U.S. Department  
of Transportation  
**Federal Highway  
Administration**

In Reply Refer To:  
HSSD/CC-88C

Name of devices: SKT-SP-MGS and FLEAT-SP-MGS W-Beam  
Guardrail Terminals for the Midwest Guardrail System  
Type of device: Midwest W-Beam Guardrail Terminals  
Test Level: NCHRP Report 350 Test Level 3  
Testing conducted by: N/A  
Date of request: May 29, 2009  
Date acknowledged: June 29, 2009

SKT-SP-MGS Terminal  
Midwest Guardrail System  
31" Top of Rail

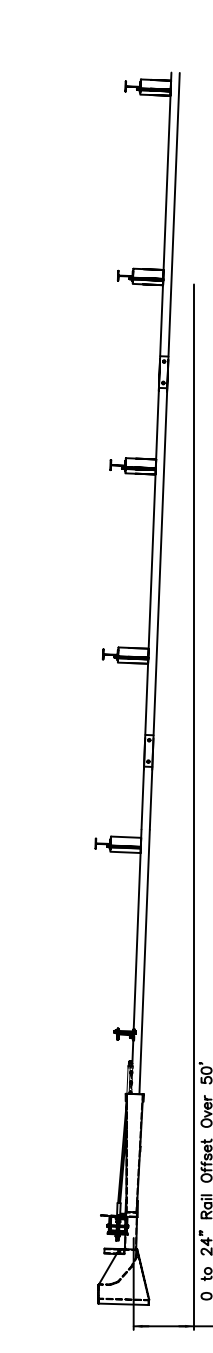
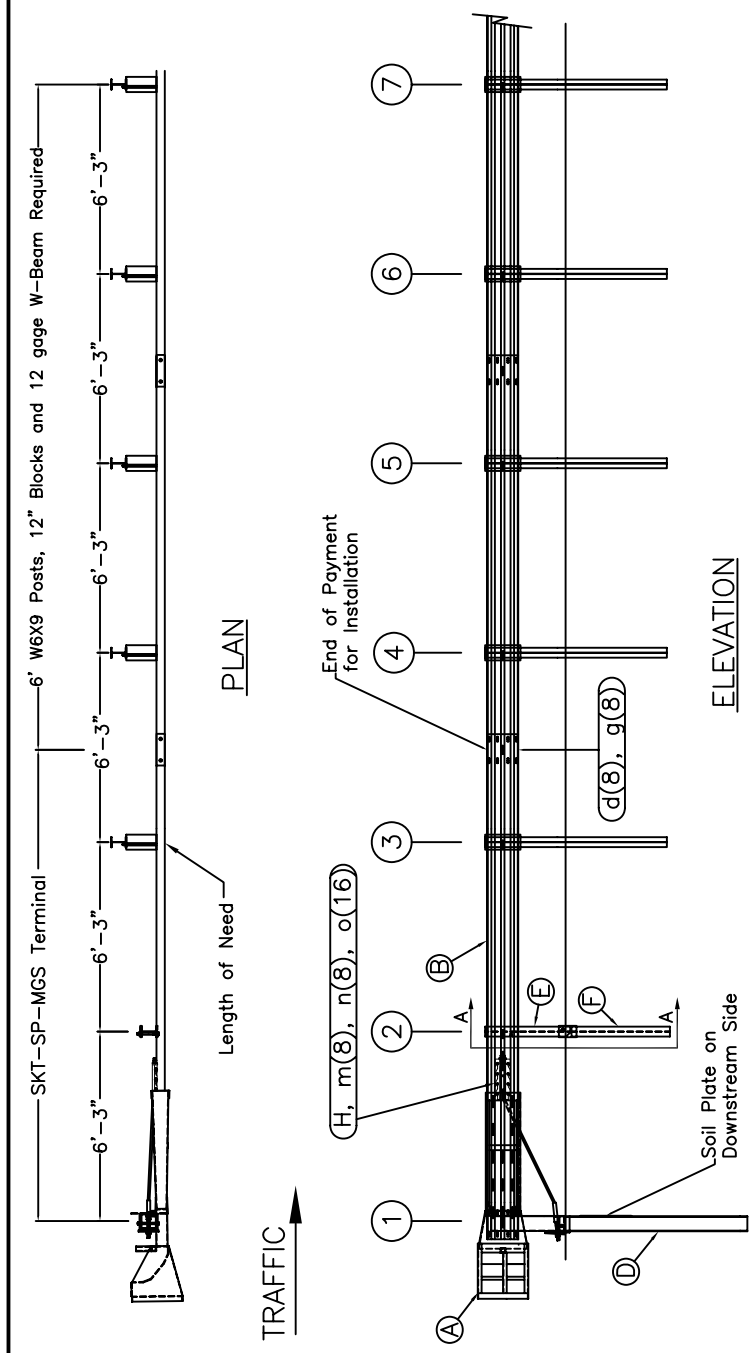
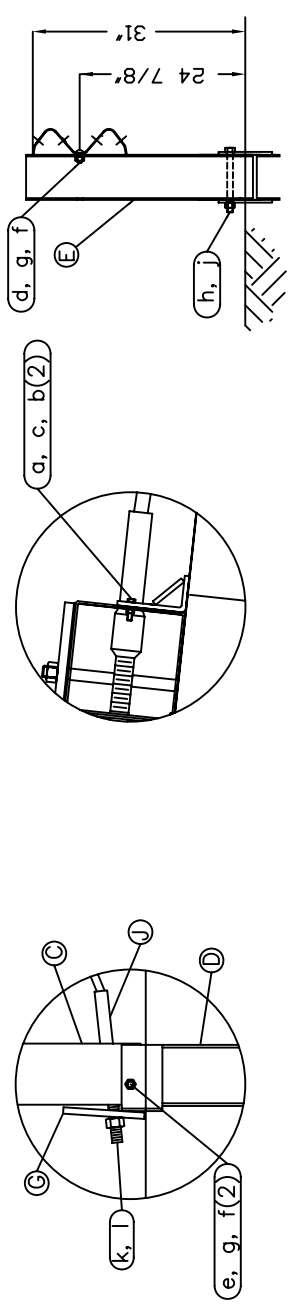
The SKT-SP-MGS and FLEAT-SP-MGS terminal drawings (enclosed for reference) with two breakaway posts for use with the MGS guardrail system show an end panel that is 3 feet, 1 1/2 inches longer for a total length of 15 feet-7 1/2 inches long in order to begin the MGS mid-span splice configuration. The end panel spans from post 1 to midspan between posts 3 and 4. The remaining W-Beam panels are all 12 feet, 6 inches long. You noted that you received a request to provide alternate lengths of the end terminal rail sections for the SKT-SP-MGS and FLEAT-SP-MGS systems so that the rail sections can be handled more easily in the field during installation/repair and also for inventory standardization with the metric height terminals. The proposed alternate design is to use a 12 foot-6 inch end rail section that spans from post 1 to post 3, followed by a special 9 foot-4 1/2 inch rail section that spans from post 3 to mid-span between posts 4 and 5, and standard 12 foot-6 inch rail sections from there on.

In your request you stated that these proposed alternate rail section lengths should not adversely affect the safety performance of the SKT-SP-MGS and FLEAT-SP-MGS terminals for a number of reasons. First, the rail splices remain at mid-span in accordance with the MGS design. Moving the splice from mid-span between posts 3 and 4 to between posts 4 and 5 should have little or no effect on the rail strength. Secondly, the critical test for rail strength is NCHRP Report 350 Test 3-35. Given that the point of impact for this test is at post 3, which is the beginning of length-of-need, the splice at post 3 should not pose any problem as has been demonstrated in previous crash tests. Finally, this rail configuration is used in another existing MGS terminal accepted by FHWA without any known in-service problems.

In summary, you concluded that no additional crash tests are required to verify the performance of both the SKT-SP-MGS and FLEAT-SP-MGS terminals with two breakaway posts for the MGS guardrail system with either the 15 feet-7 1/2 inches long or the 12 foot-6 inch long end rail section. You asked that the optional length end rail sections be applicable to all SKT and FLEAT MGS terminals. We concur in these requests.

The modified FLEAT-SP-MGS and SKT-SP-MGS terminals described above and detailed in the enclosed drawings are acceptable for use on the NHS under the range of conditions tested, when acceptable to a highway agency.
